Re: Appeal of CEQA Categorical Exemption Determination
Planning Case No. 2013.1383ENV
Building Permit Application Nos. 2013.12.16.4318 & 2013.12.16.4322
3516-3526 Folsom Street ("Project Site")

Subject: Independent Project Review
3516 & 3526 Folsom Street
San Francisco, California

Figure 5: Approximate PG&E transmission gas line alignment relative to proposed structures.

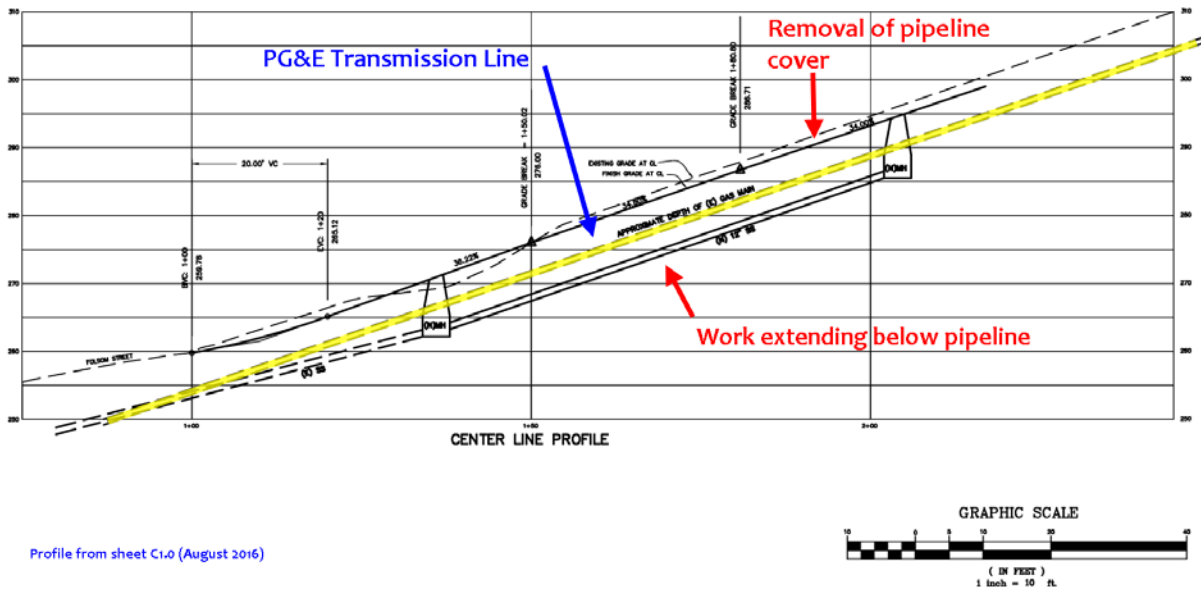
The proposed projects are located immediately adjacent to a major PG&E transmission natural gas pipeline (Figure 1, Figure 2, Figure 3). This major pipeline is located immediately below the primary access road for the construction (Figure 4, Figure 5), immediately adjacent to significant proposed new utility work (e.g. gas service, water supply, sewer) as well as removal of existing pipeline soil cover (Figure 6, Figure 7), and immediately adjacent to significant proposed bedrock excavation (depths on the order of 6 to 10 feet per the submitted architectural elevations (such as sheet A-3), as seen in .

Construction-related stressing, as well as accidental 3rd party damage, has the potential to degrade the integrity of the PG&E natural gas transmission line, exposing the surrounding neighbors to increased risk of death and injury from the potential of construction-induced puncture or degradation of pipeline integrity.

Figure 6: Plans call for removal of pipeline cover as well as construction work below the existing pipeline.

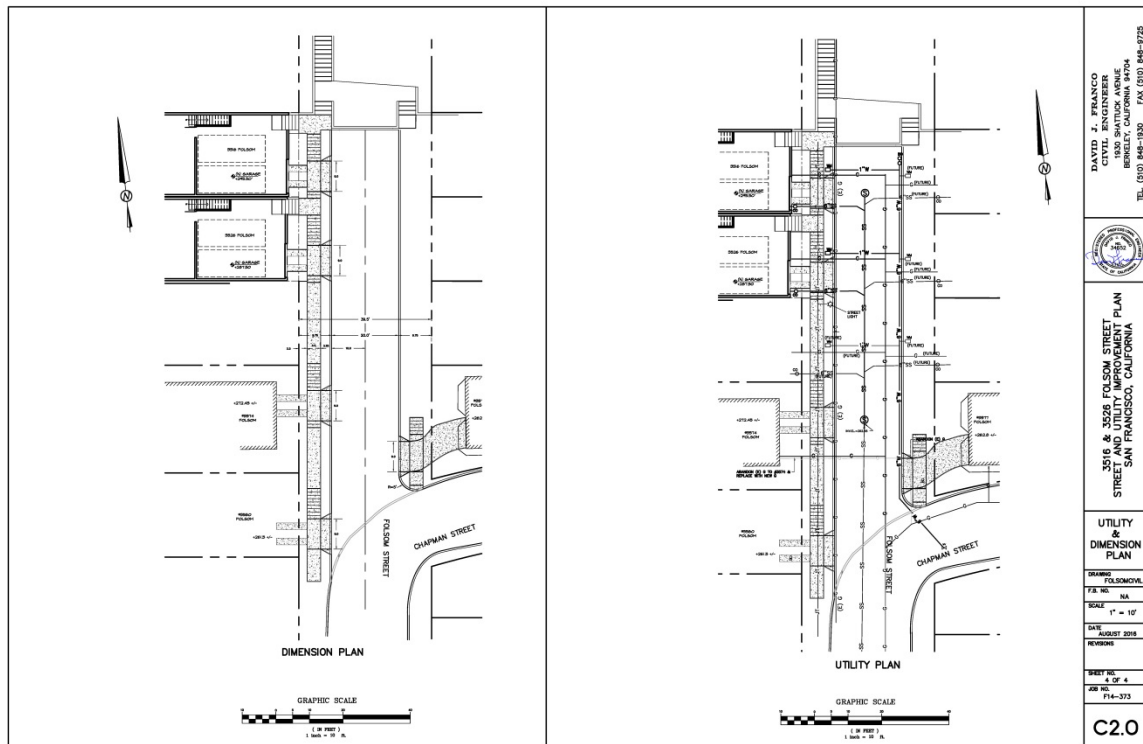
- Geotechnical borings do not extend to the proposed depth of excavation, providing information on competence of bedrock and anticipated level of effort to excavate;
- No explicit discussion about induced ground vibrations during rock excavation and associated potential degradation of the PG&E transmission line integrity;
- No explicit discussion about negative impacts of construction traffic to the PG&E transmission line integrity; and
- Significant construction operations immediately adjacent to the active PG&E transmission pipeline.
